Quotation date	21.12.2022	CP Interiors
Quotation number	20057293	St. Saviour
Customer number	1001334	28 Rue des Pres. Tr. Est.
Your VAT number		JE2 7QN JERSEY
Currency	GBP	JERSEY
Project reference	S013682 COLLIE	
Order reference	SO13682	
Validity from-to	21.12.2022 - 20.01.2023

From: Rachel Allo
Sent: 30 November 2022 11:44
To: Harris Collie
Subject: RE: Quotation ref SO13682

REF : SO13682

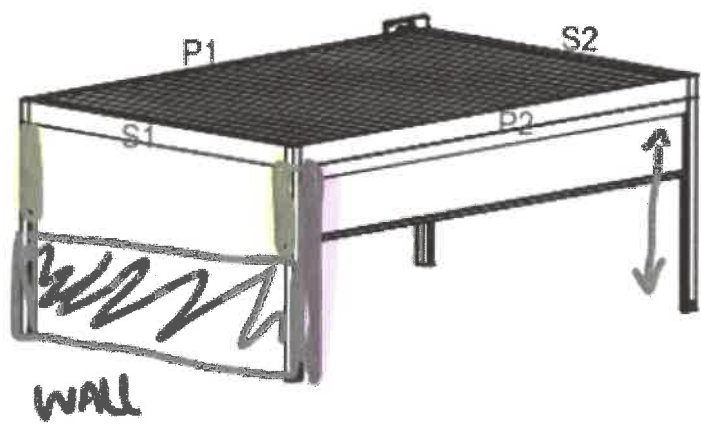
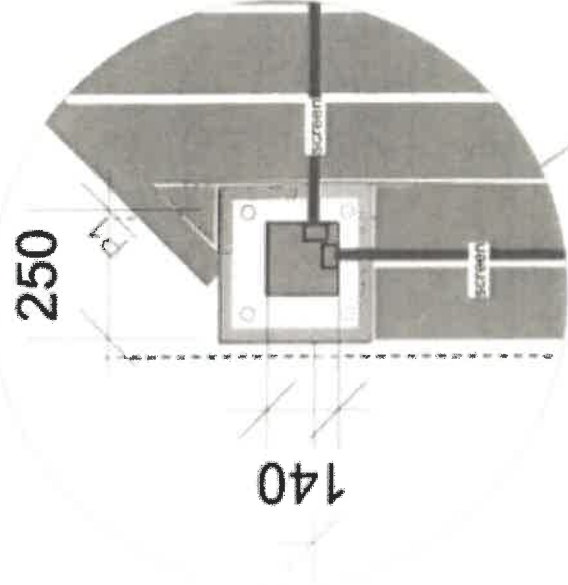
Protect?
 Drainage?
 Confection side?

Section A

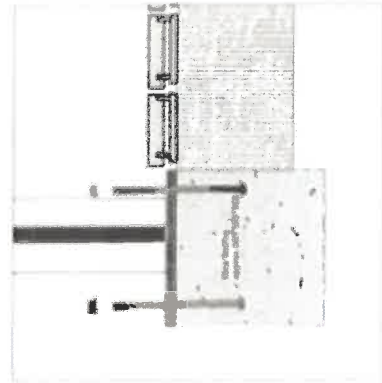
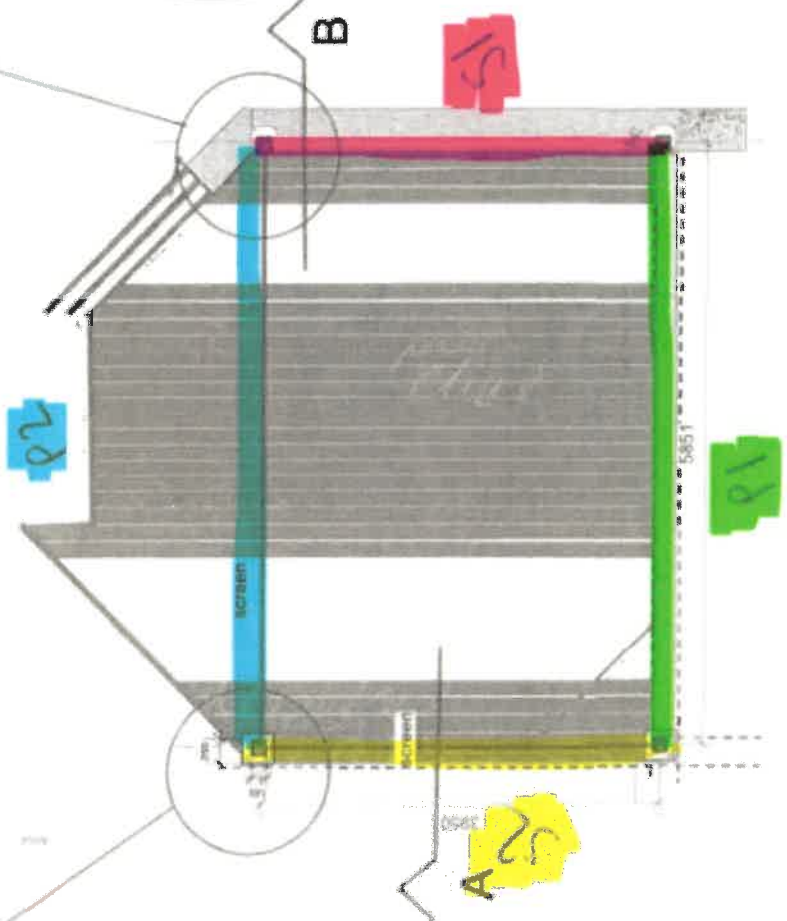
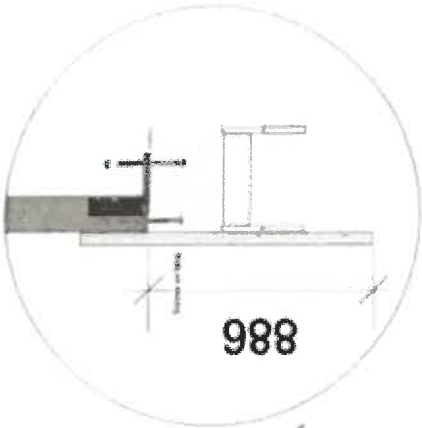
Wiggle room
10-20 mm??

I am working with Renson on your proposed project and just wanted you to make clear a few things if possible please to get you a more accurate proposal.

I have labelled **P2/S1/P1/S2** (which refers to our pivot and span lengths) and am going to use these as easy reference points or my questions.

- 1) could you please confirm which sides you would like the up lighting quoted on? All 4 sides or just 2 sides for example P1 and P2 or vice versa S1 and S2?

- 2) P1 – is this greyed out area also a wall or is it the side of the house? 891.
- 3) S1 – could you please confirm for me the height of the low wall and subsequently if you have a maximum height to work towards. The portal will require what they call a negative overlength which essentially would be the passage height minus the wall height. Passage height is the calculation from the floor to the underside of the top beam (allow +260mm on top of this to the top side of the framework).

- 4) In my second drawing (please note colours do not coordinate with previous) the red area is the wall, the two green posts are the original posts from S1 which will sit on the wall and the blue column is an additional post which will allow the screen to drop down full length to the floor on side P2.

Section A

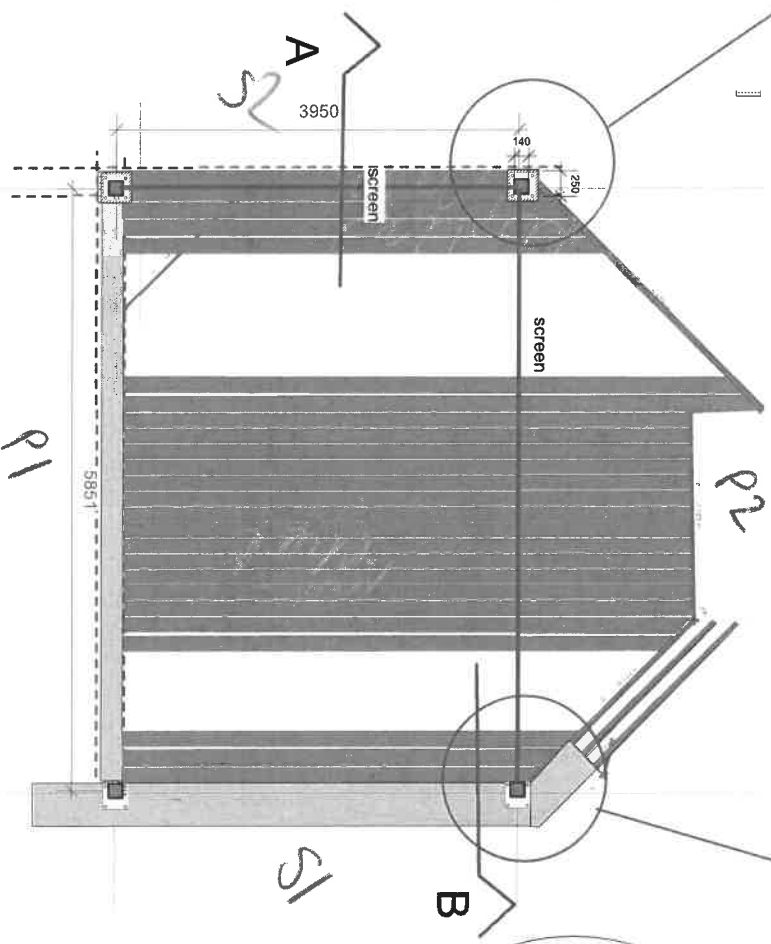
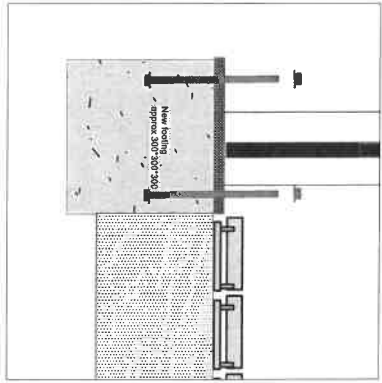
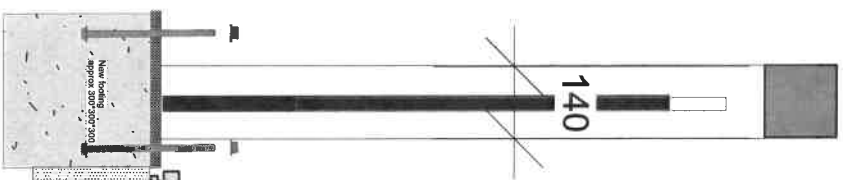
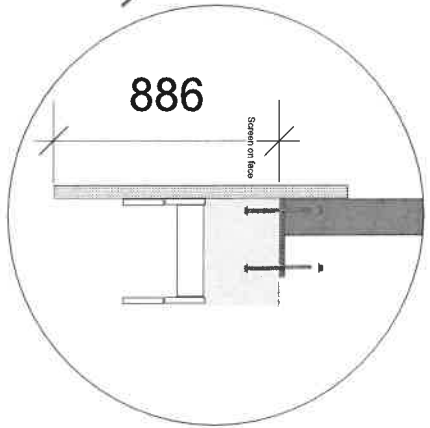
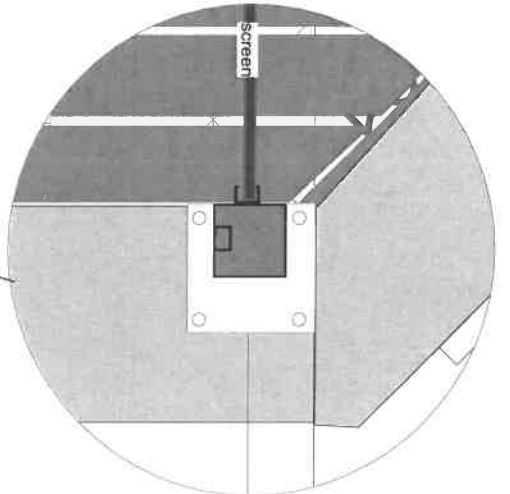
Wiggle room
10-20 mm??

It was 4500*6055 it is now 3950* 5851.

Could this mean a reduced price?

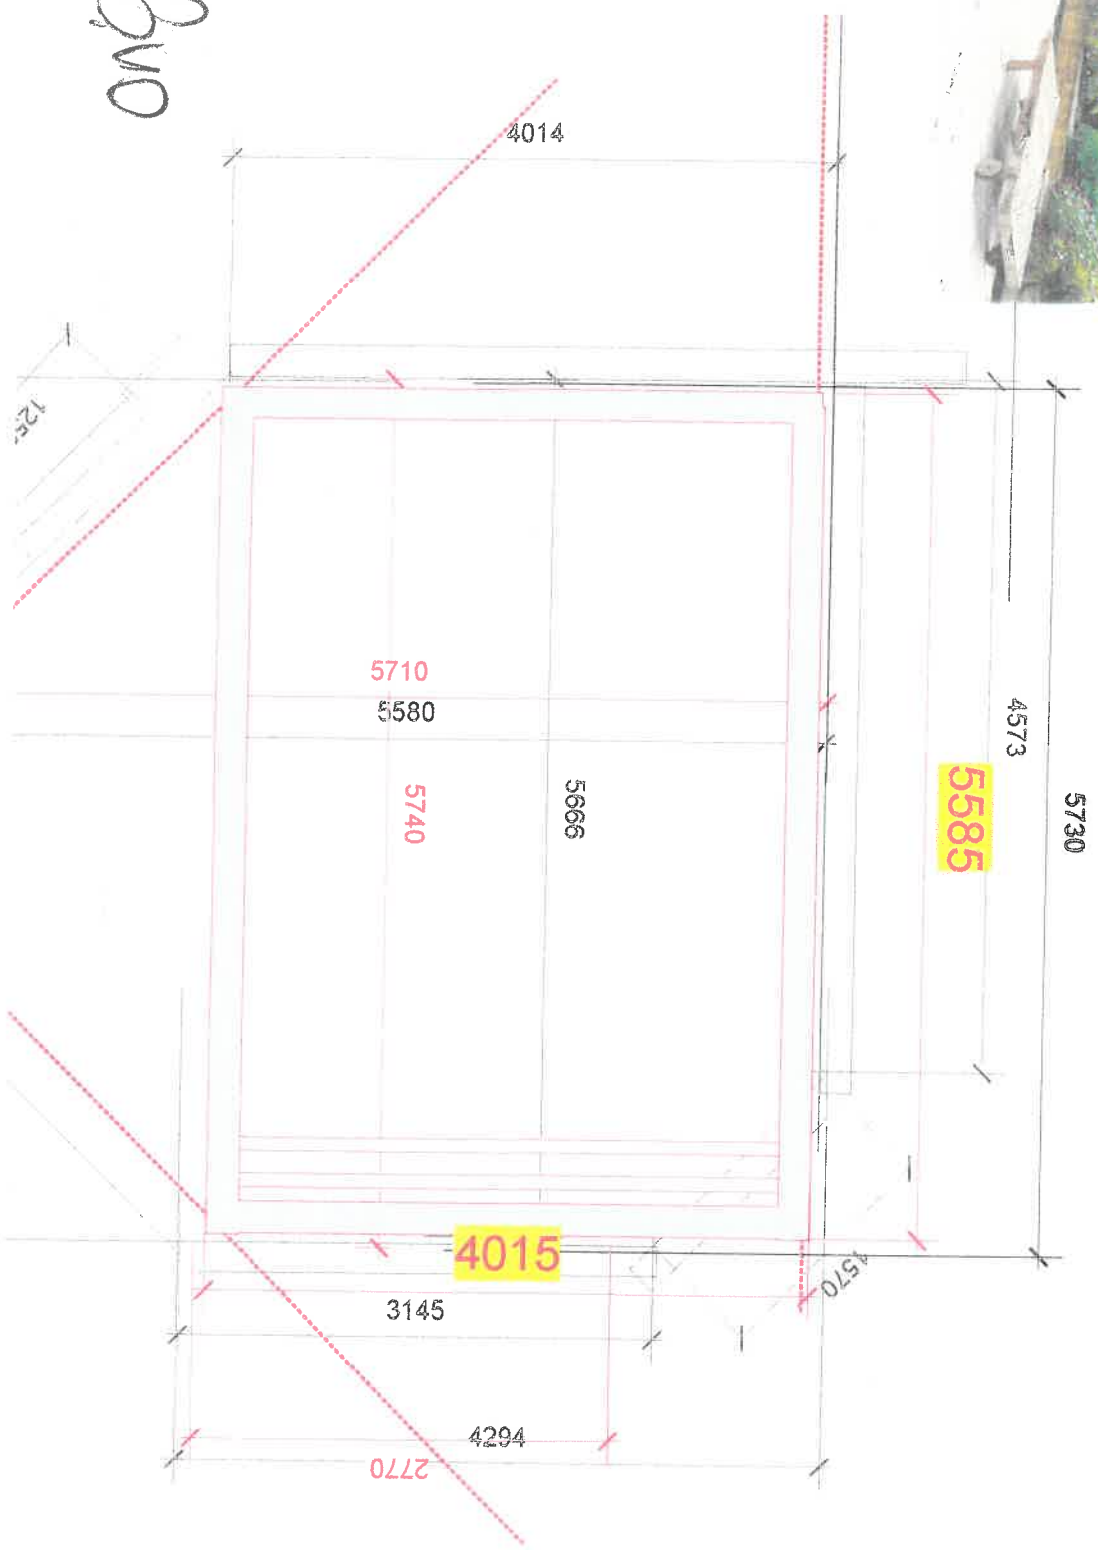
1x 1800mm Skender. = Maybe continue down
 Side of wall?
 - Send drawings on Reel, if you
 interested

* add size of "half height" to notes &
 request quote - they can do lower
 than 1800mm.

Renson Camargue

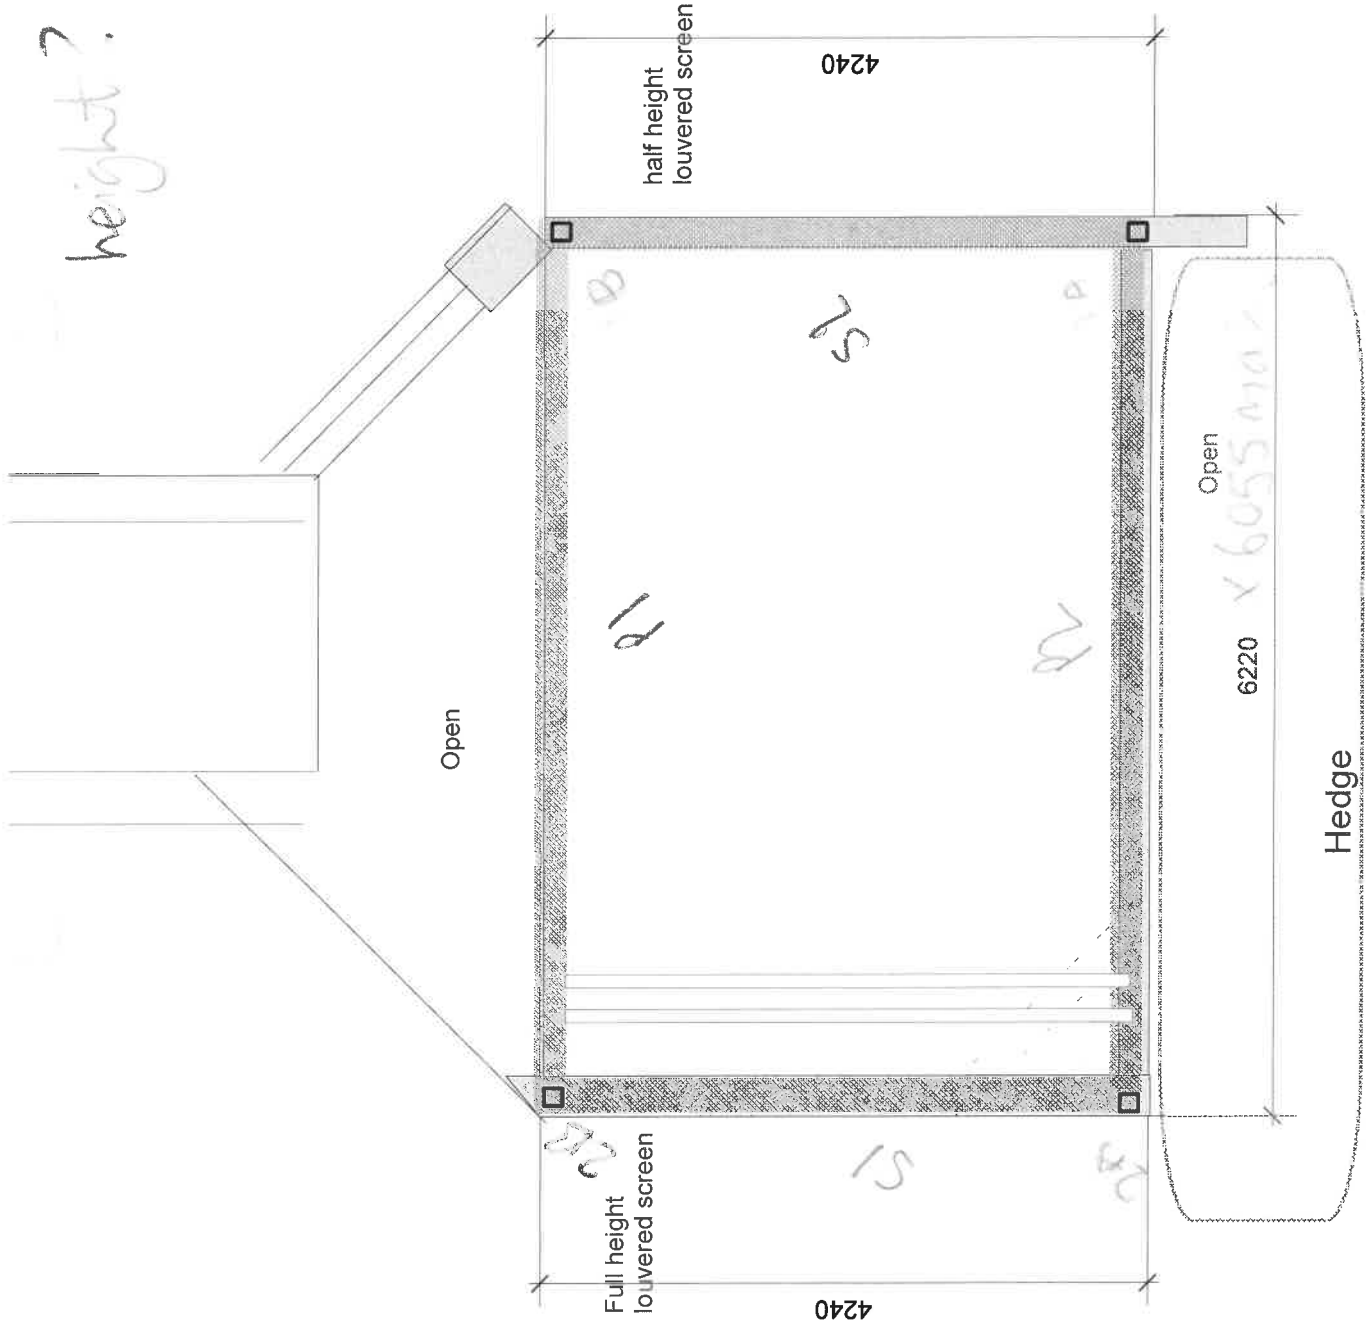
height? 2300 based on
